*Southern California Edison Company*

Subject: Docket No. 50-206  
NUREG-0737 Item II.D.1-Performance Testing of  
Relief and Safety Valves  
San Onofre Nuclear Generating Station  
Unit 1

RESPONSES TO NRC QUESTIONS ON  
PRESSURIZER RELIEF AND SAFETY VALVE TESTING  
SAN ONOFRE NUCLEAR GENERATING STATION  
UNIT 1

Figure C-1. Comparison between calculated hydrodynamic forcing functions on pipe segment L11 (RELAPS isentropic flow case versus SCE).

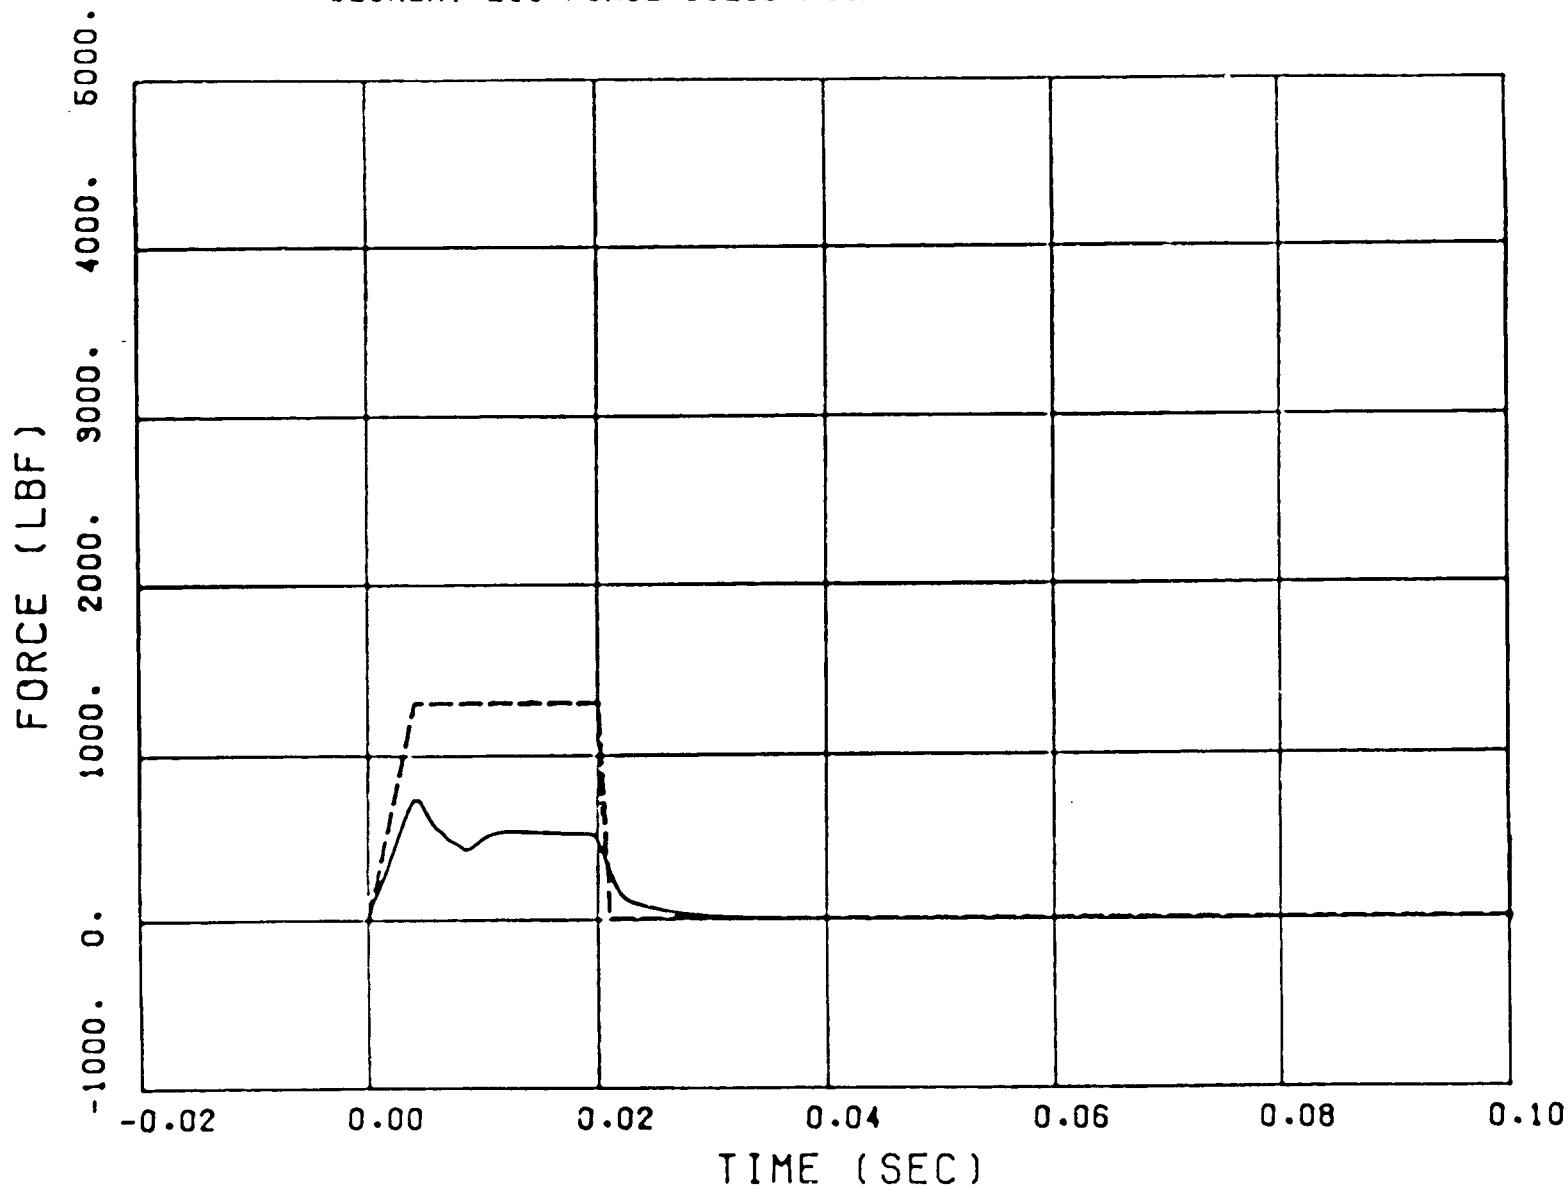
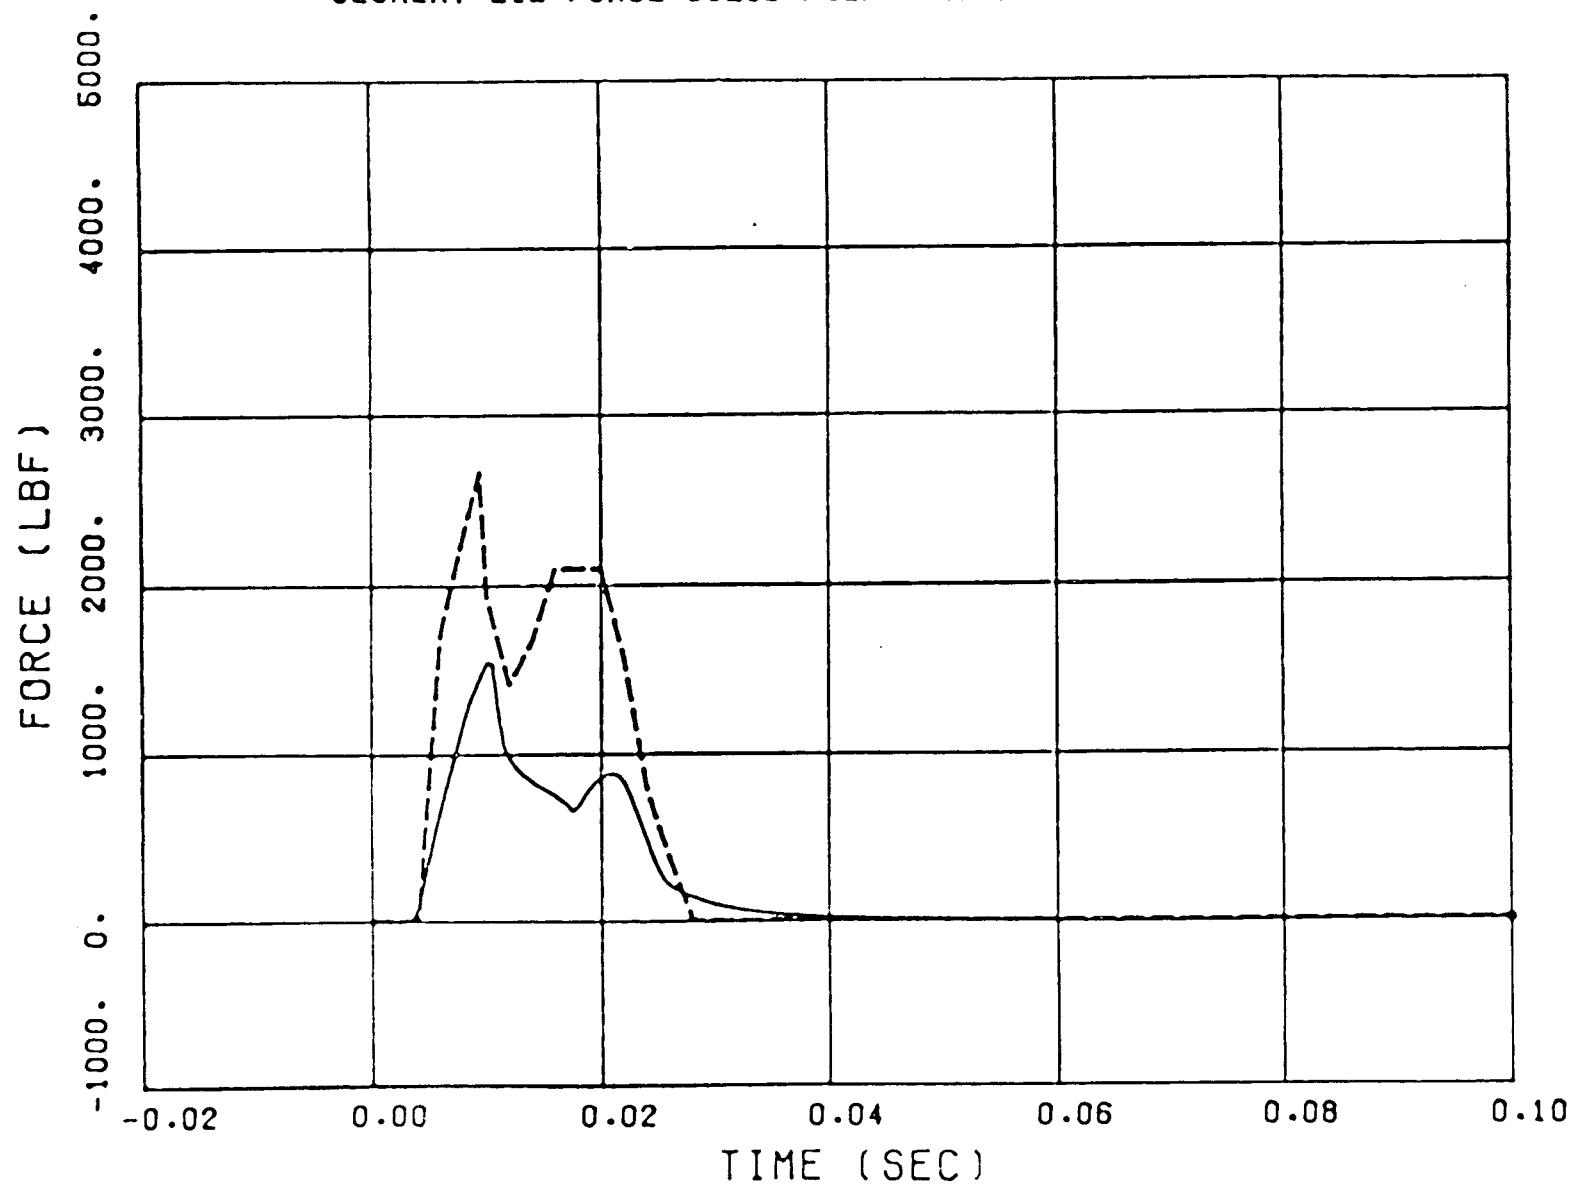
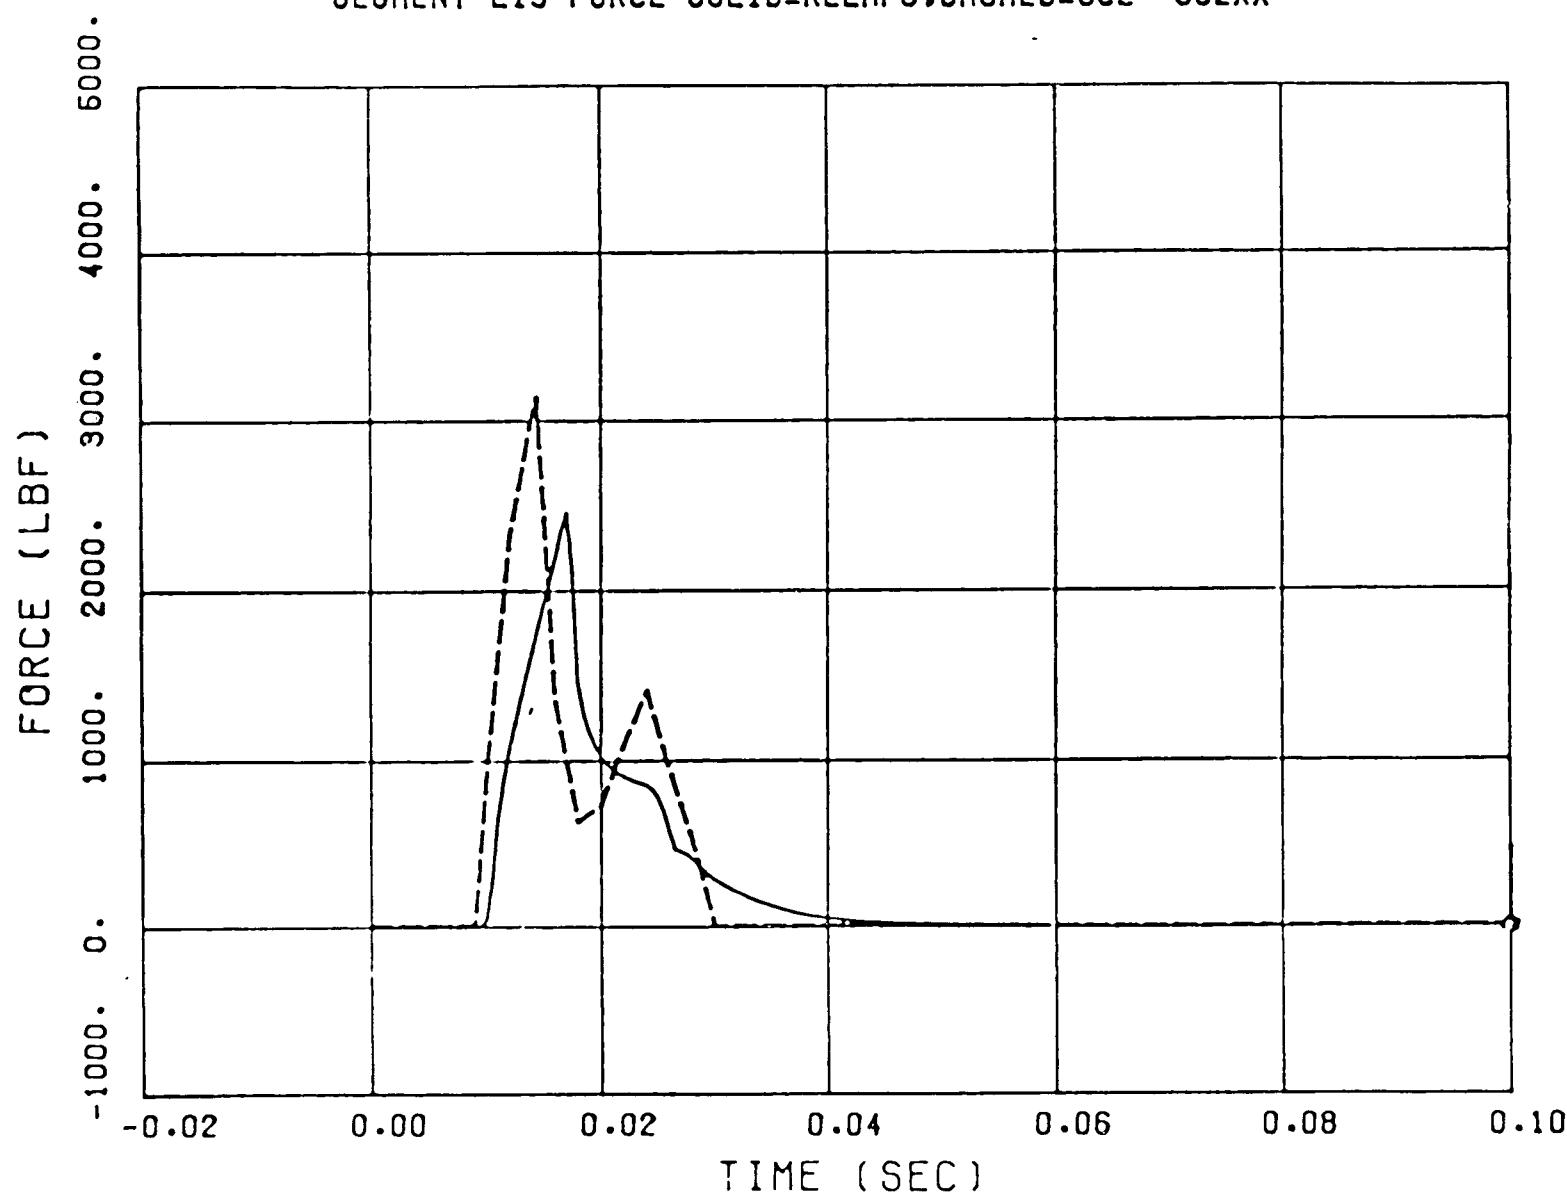
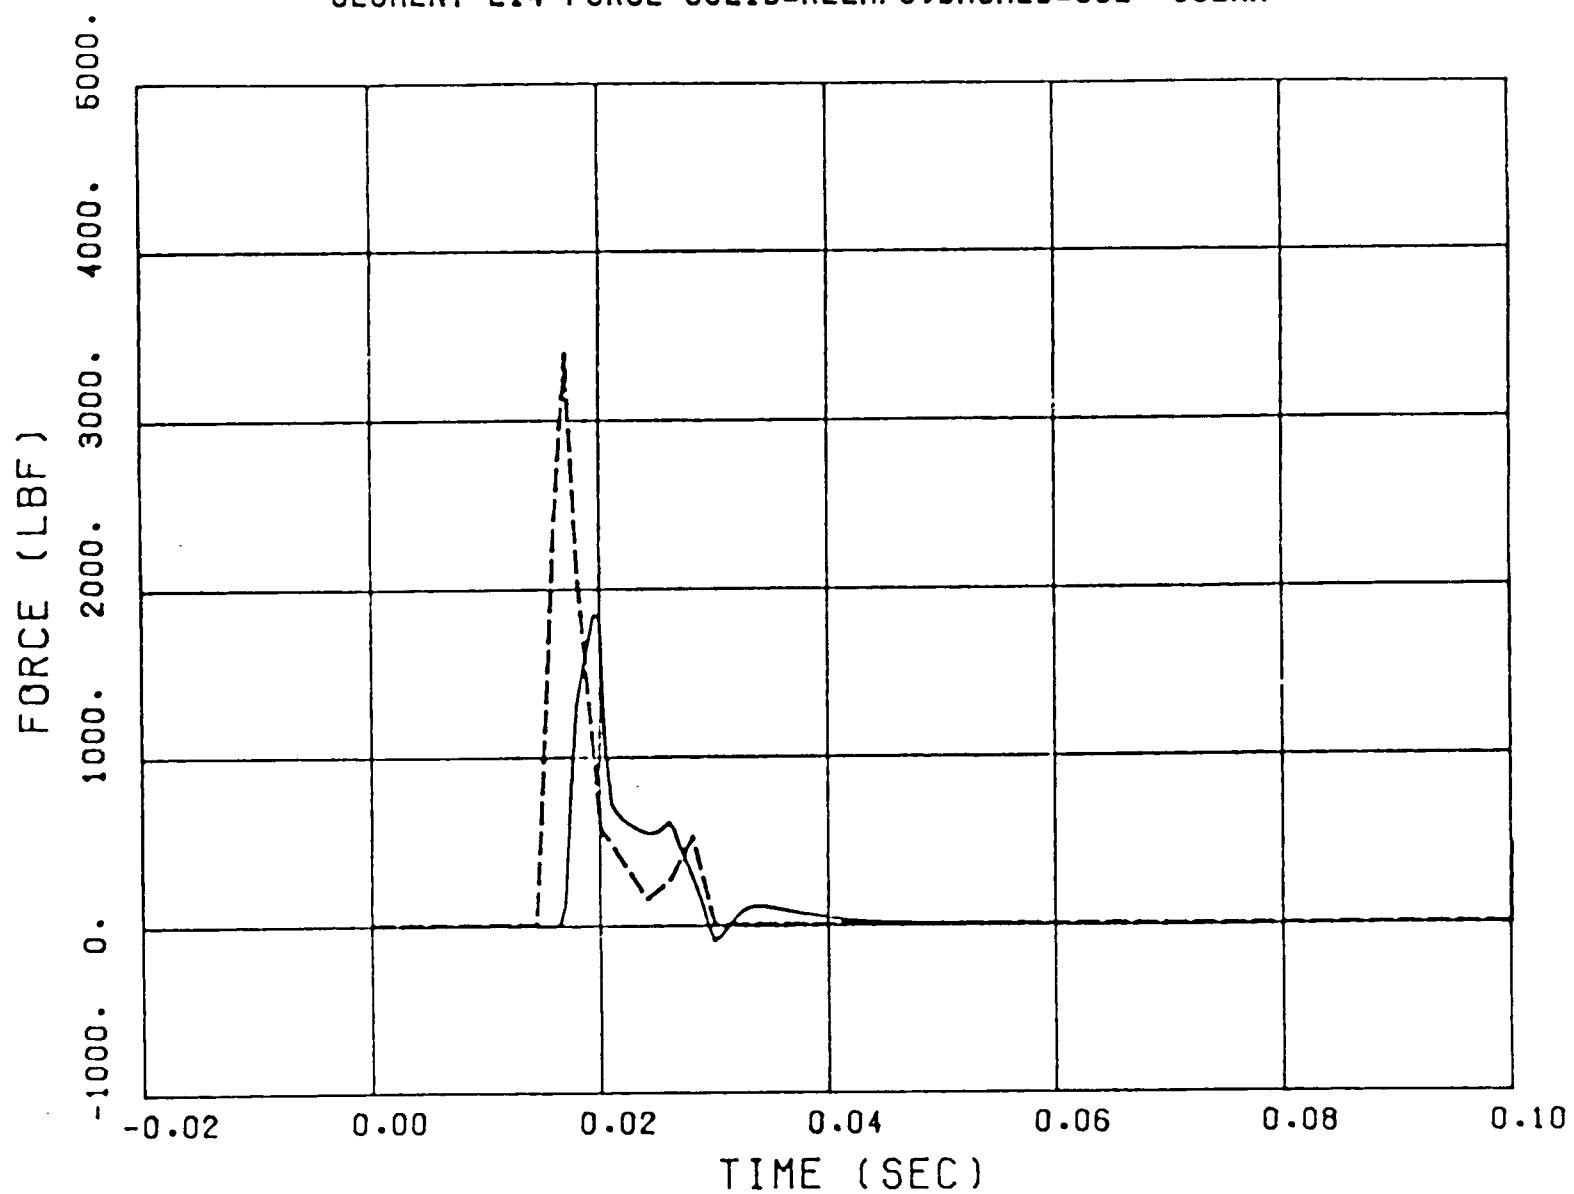
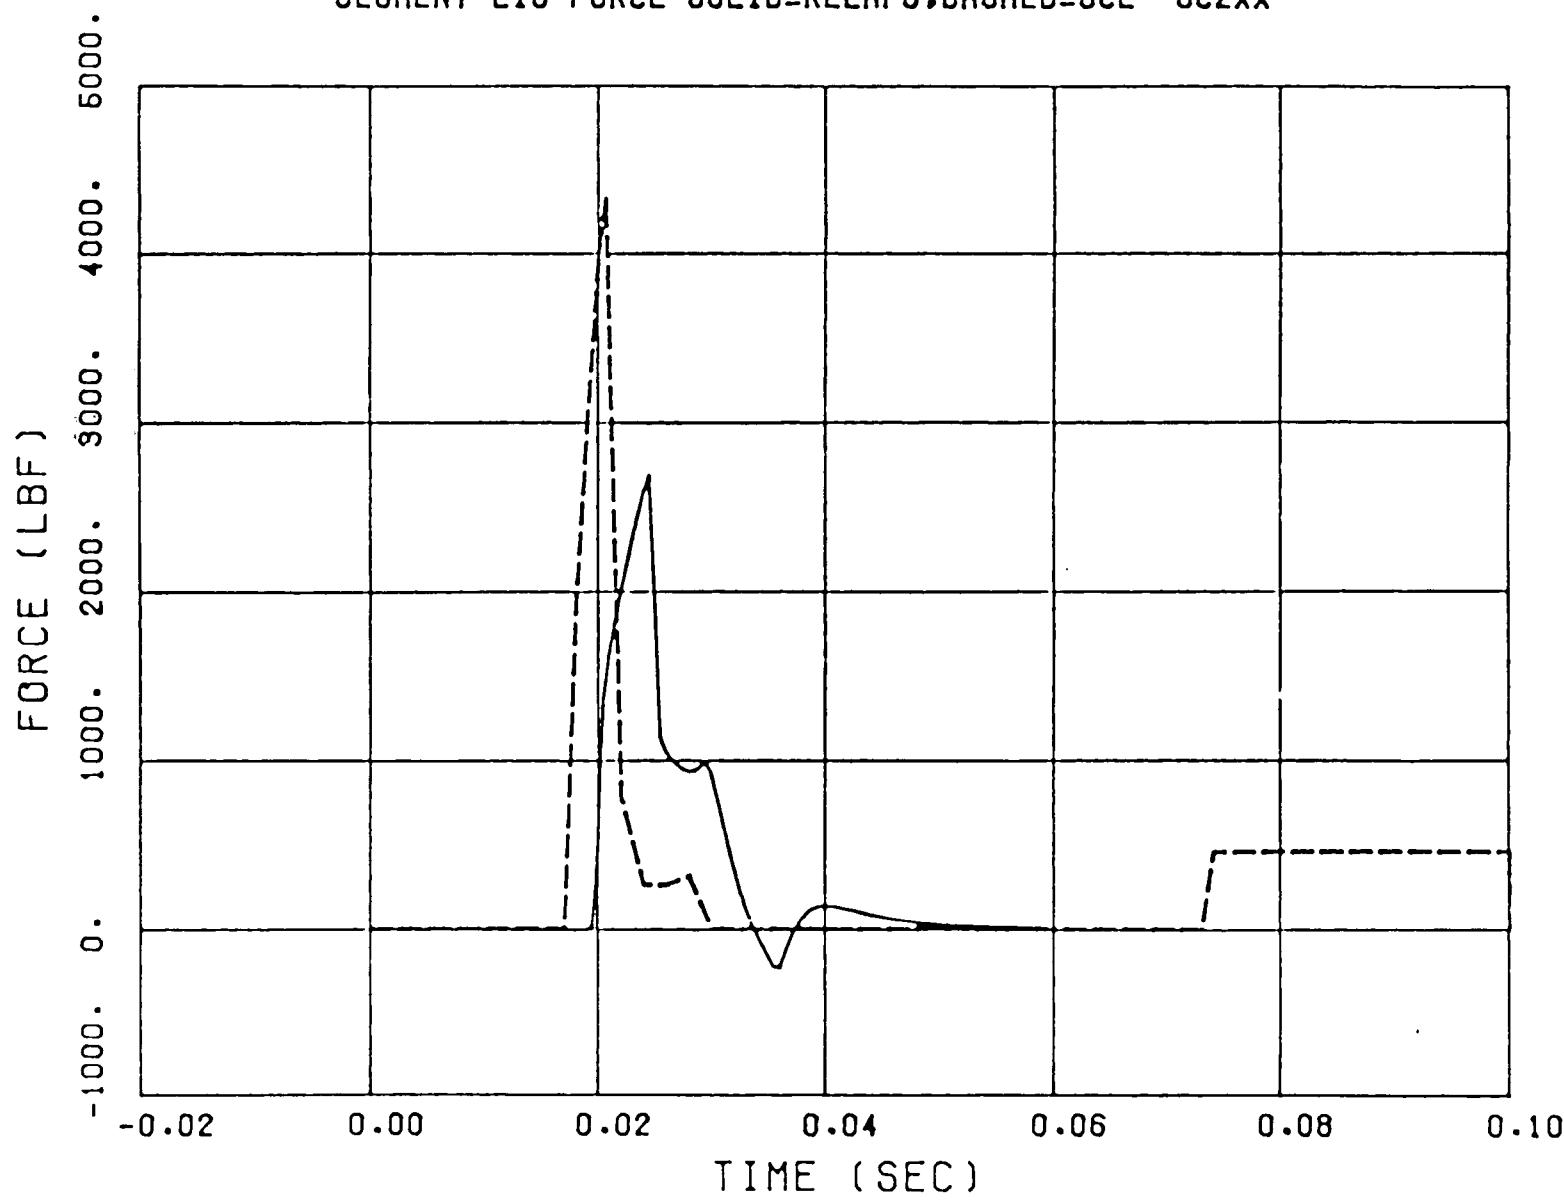
To calculate the time-dependent forcing functions acting on the piping a simplified graphical solution technique was applied. This technique is based on an ideal gas assumption. High pressure steam, though, is not an ideal gas. How well the technique applies to PWR conditions has not been demonstrated. The authors of the paper on this technique did compare calculations with test data for steam at 995 psia and obtained a good comparison. Provide further comparisons or verification to show the validity of this technique for PWR steam discharges.

Intermountain Technologies, Inc. (ITI), in Idaho Falls, was asked to evaluate independently the hydrodynamic loads due to valve actuation on the discharge piping using RELAP 5/MOD 1 Code. The analysis was for saturated steam upstream of the safety valves without assuming an ideal gas. The results of ITI's report are shown in Figures C-1 through C-7. These results demonstrate that SCE's results using simplified graphic solutions based on an ideal-gas assumption show good comparison in force characteristics and conservative data in force magnitudes. The discrepancy in Figure C-7 is judged not to be of any significant consequence because of the significant margins in all other pipe segments.
